Transportation Memorandum and
LADOT Approval

MEMORANDUM

RE: Design of Sunset & Beaudry
1111 Sunset Mixed-Use Project

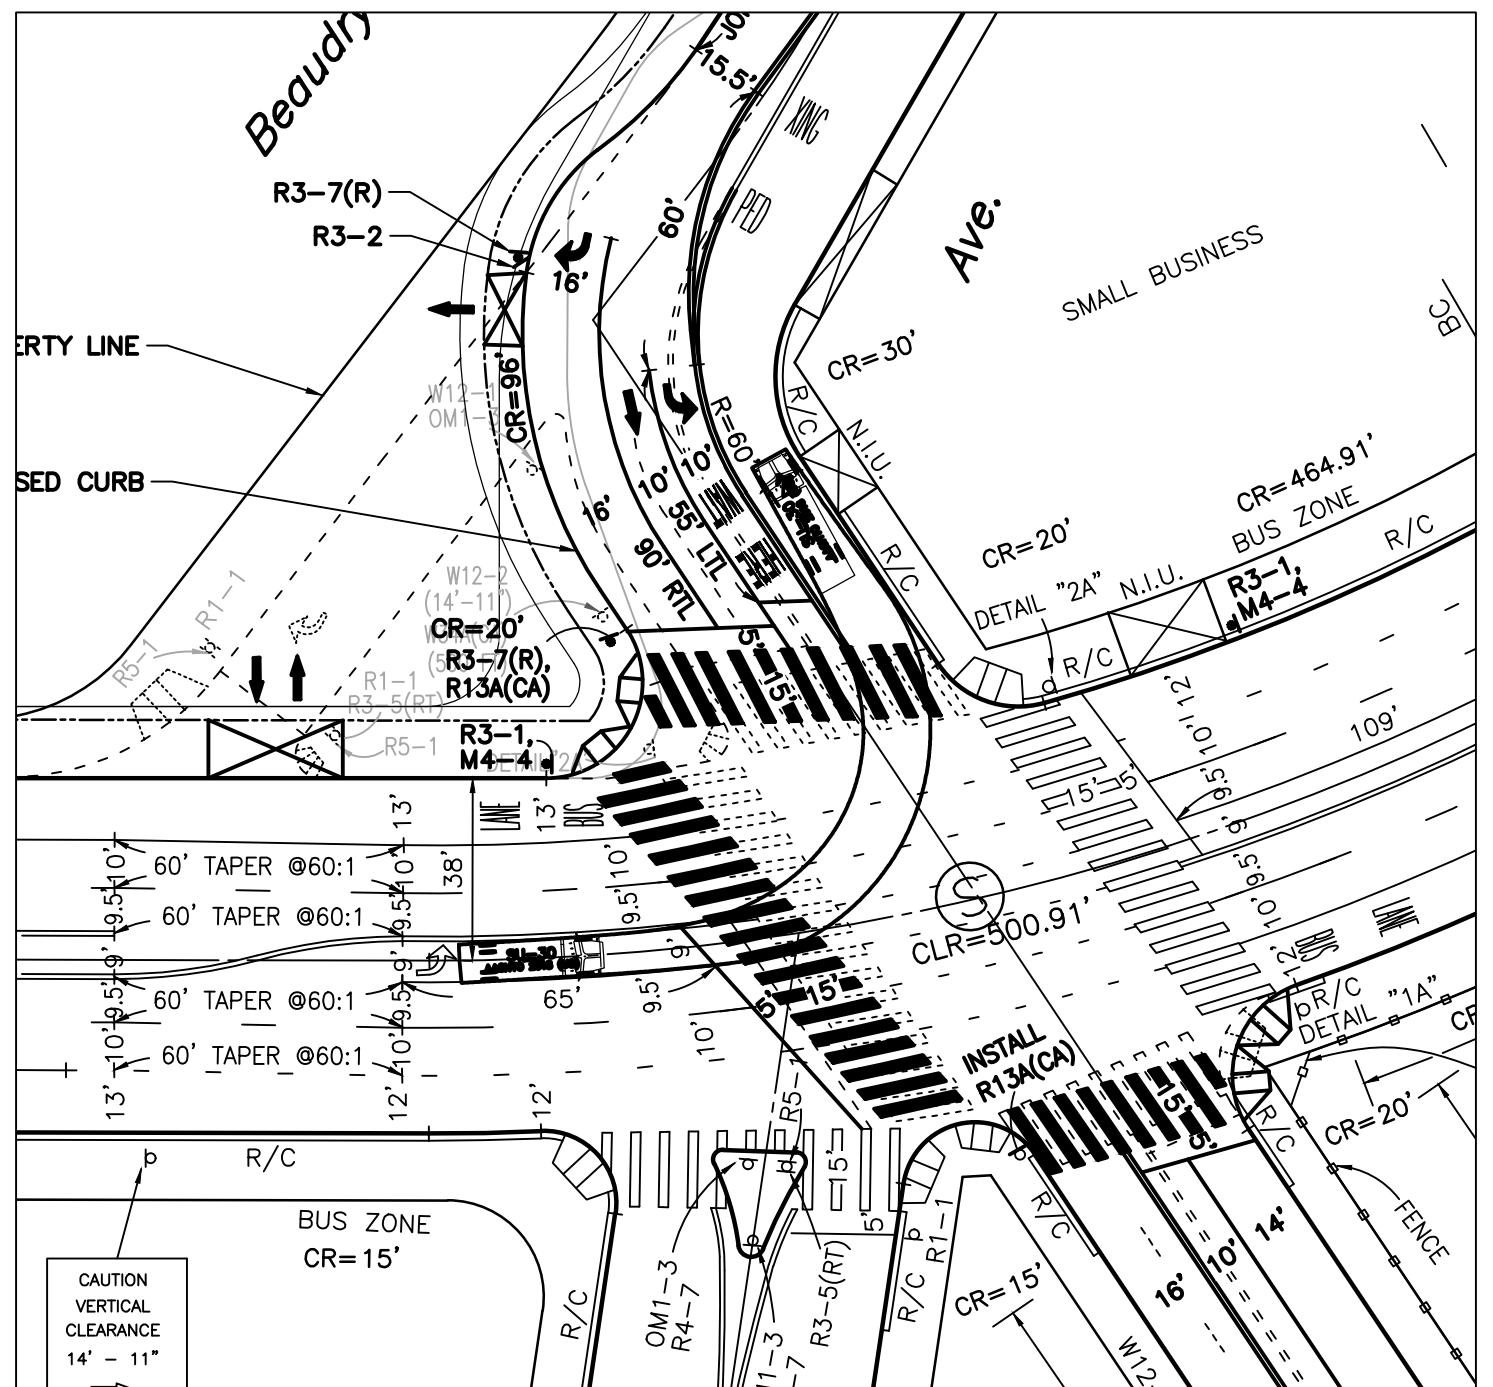
Upon review of the design proposed in the DEIR, LADOT Design Division made some minor changes to the design, primarily to facilitate large truck turns through the intersection. Figure 1A shows the Modified Design suggested by LADOT.

In the southeast corner of the intersection, a larger curb radius was developed that would allow northbound trucks to turn right onto EB Sunset without encroaching into the westbound Sunset lanes. The center lane on the south leg was narrowed slightly to allow wider curb lanes to facilitate truck turns to/from Sunset Boulevard.

The north leg of the intersection had the most changes. The northbound lane was widened and the stop line was shifted to the north a few feet to give trucks turning from Sunset Boulevard more room to make the turn. The three southbound lanes were shifted and realigned to increase the storage length of the lanes. The storage length of the right turn lane was increased the most because the SB lane will likely operate under a No Right Turn on Red restriction due to the sight distance limitation caused by the location of the existing building on the northeast corner of the intersection.

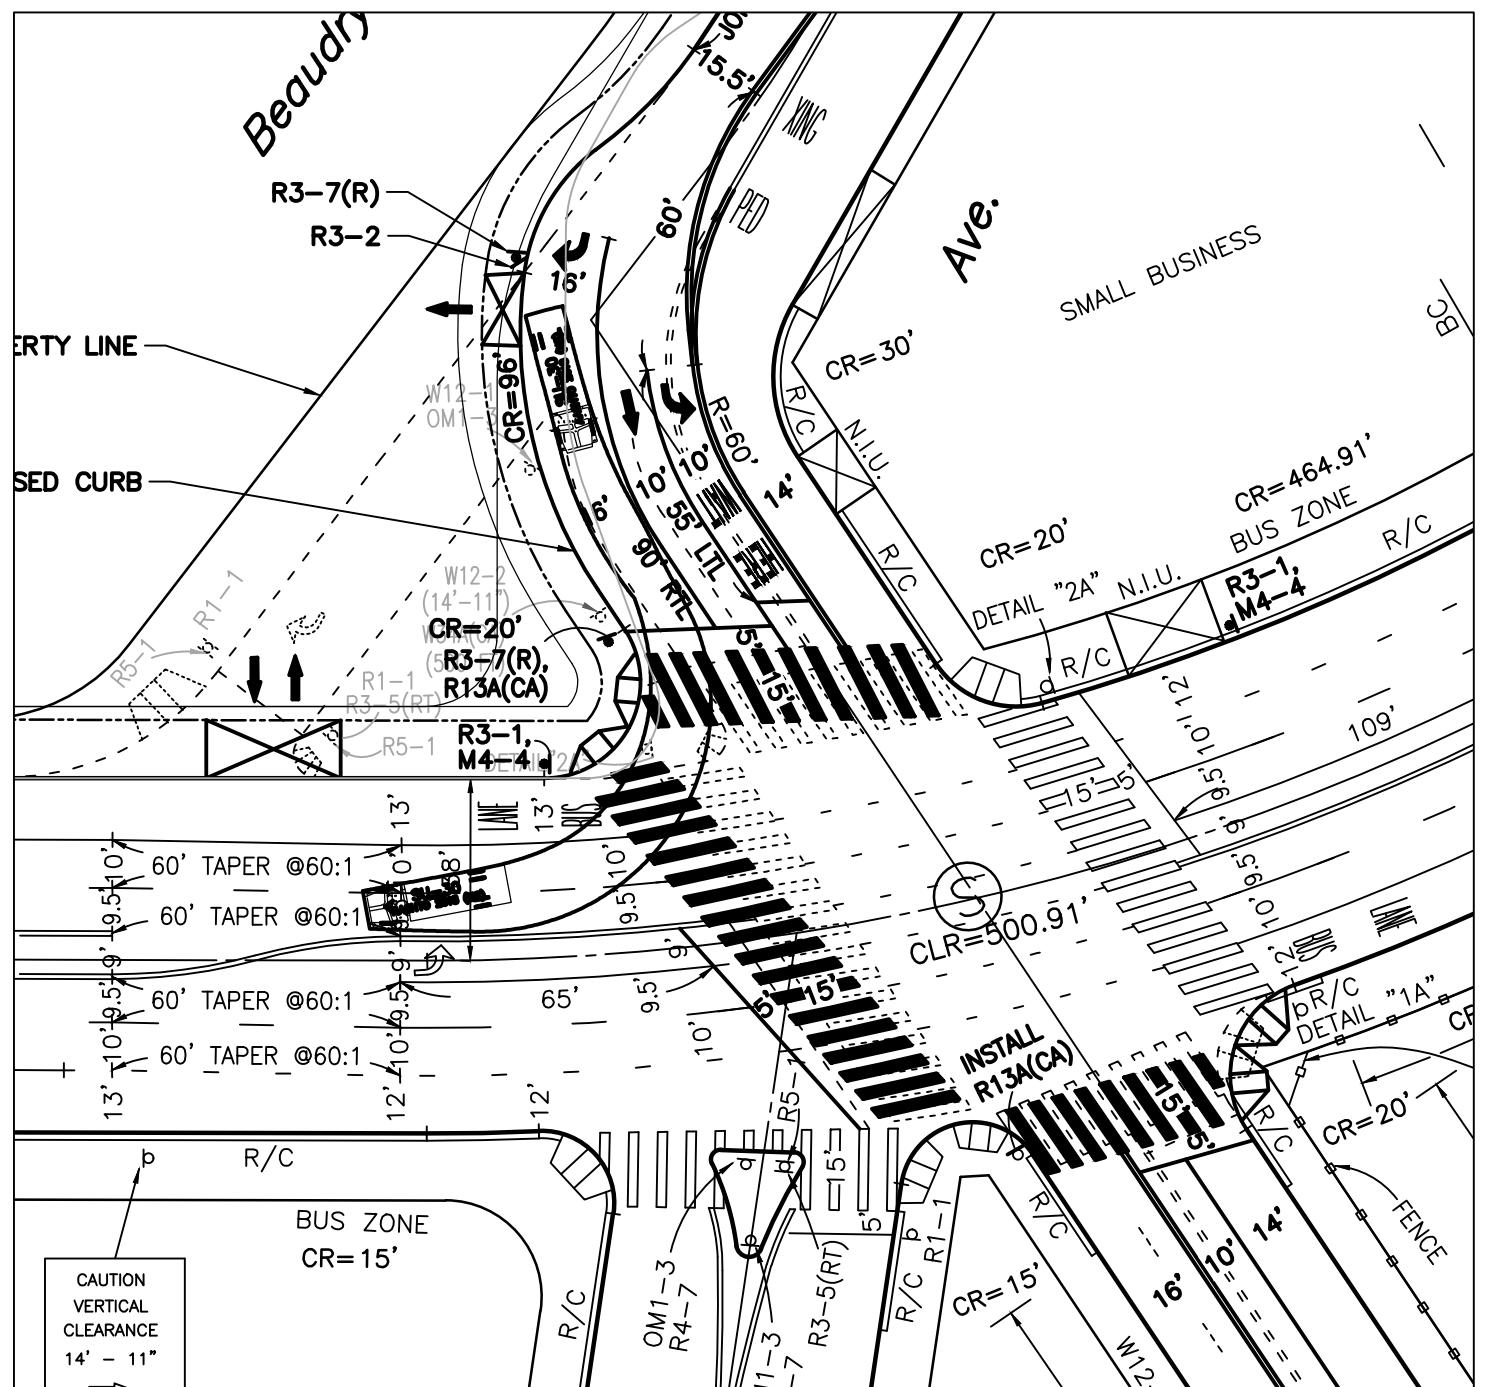
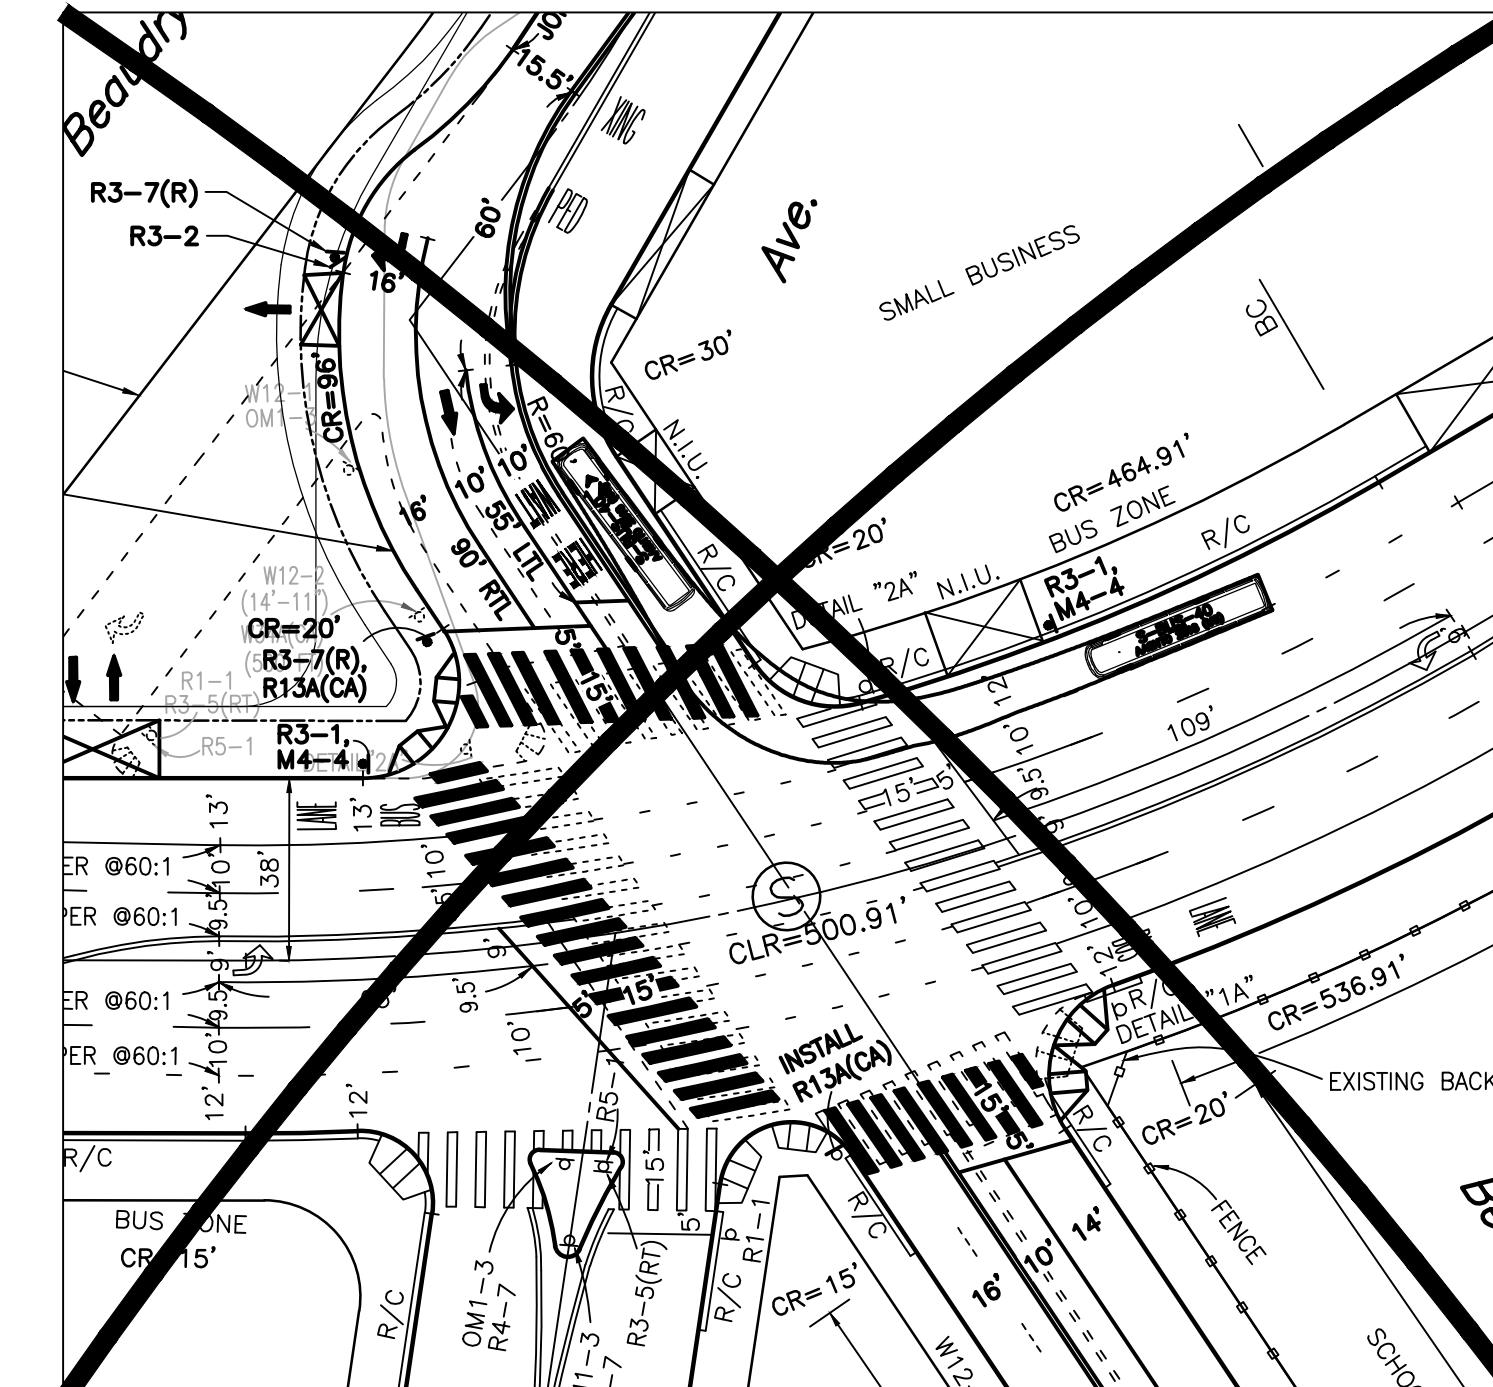
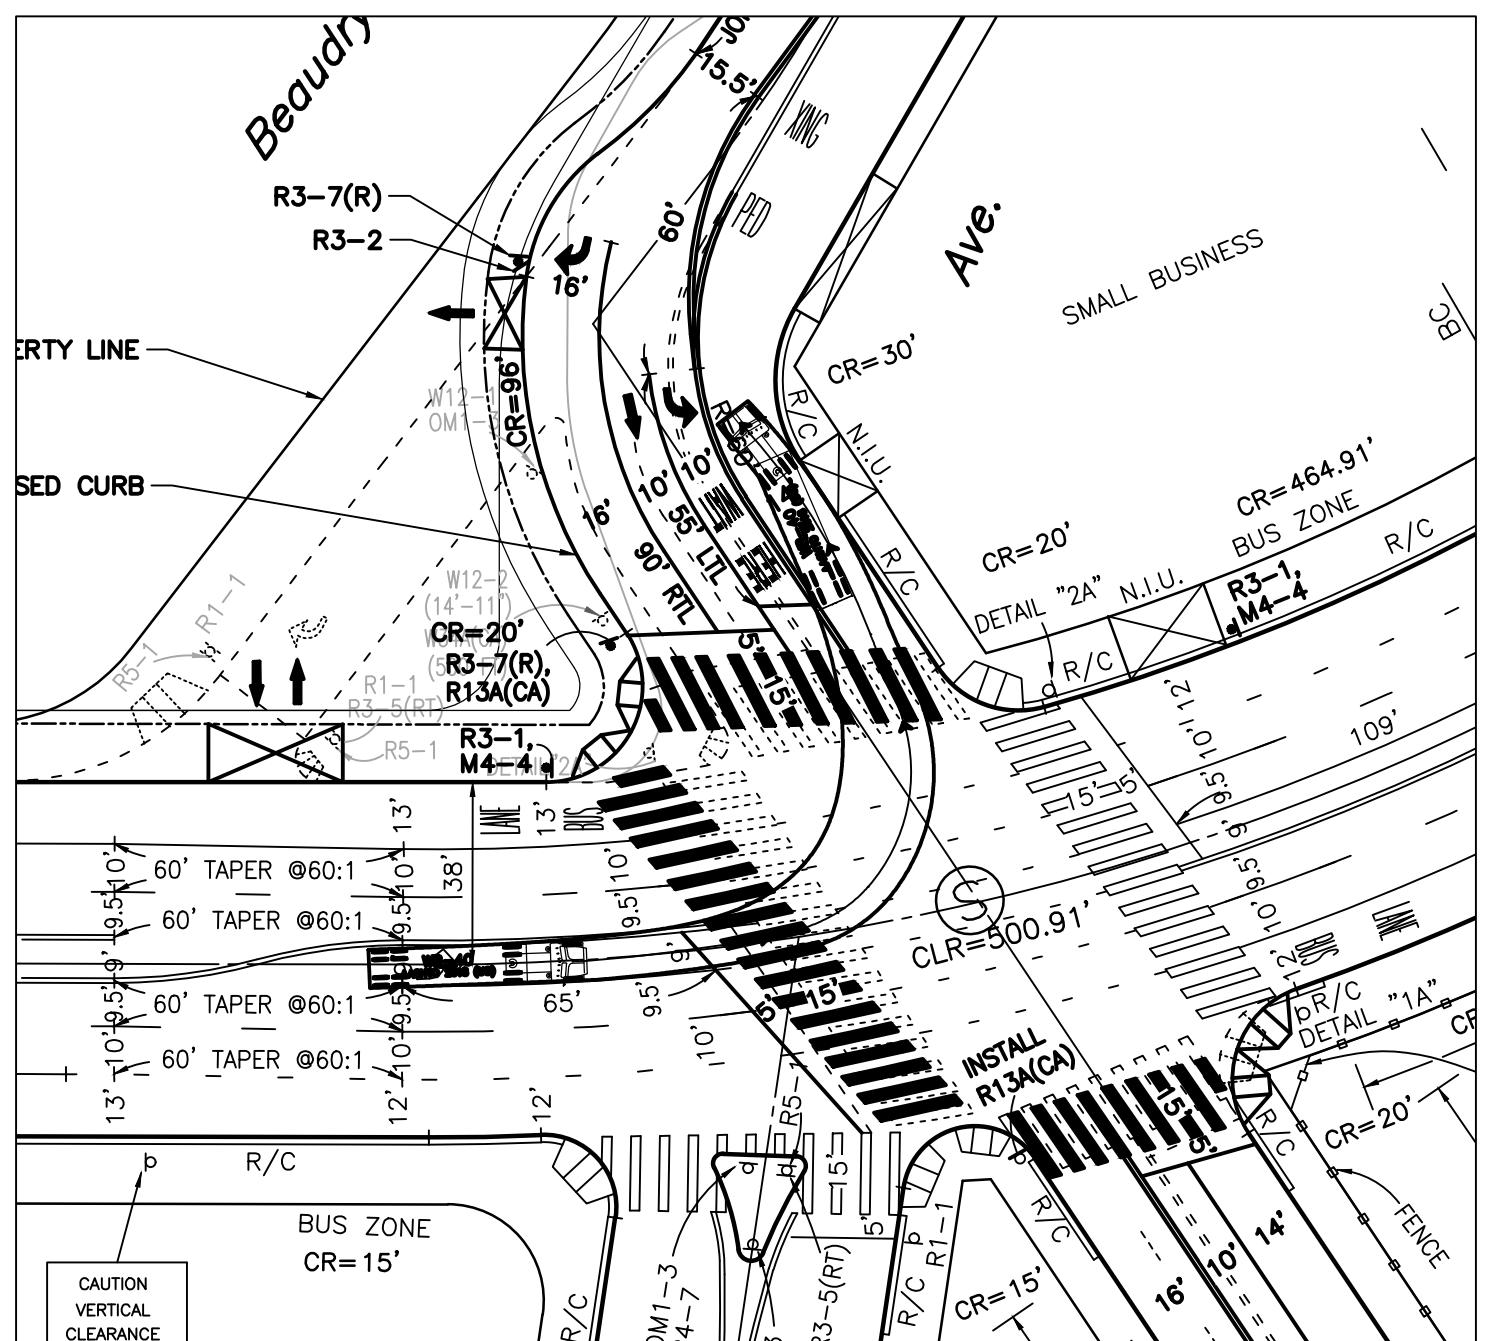
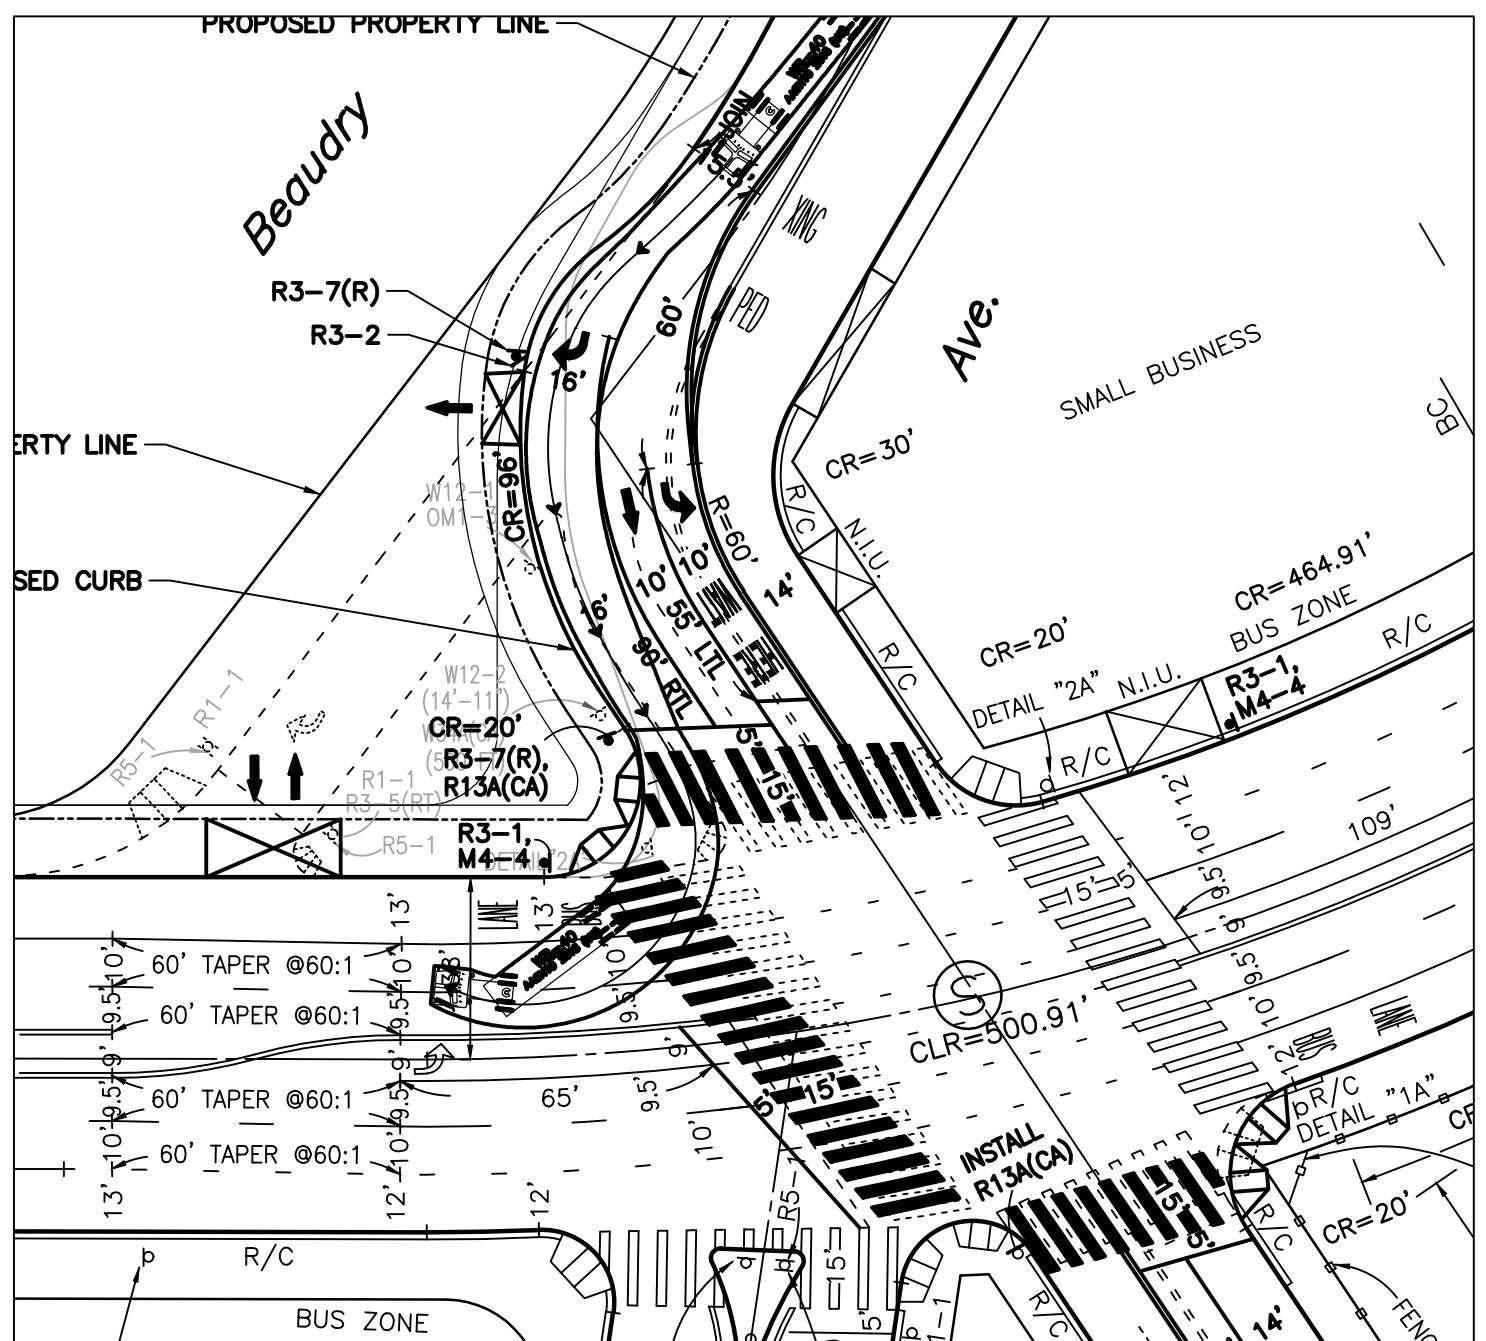
Figures 1B and 1C show the tests of the truck turning movements from each leg of the intersection.
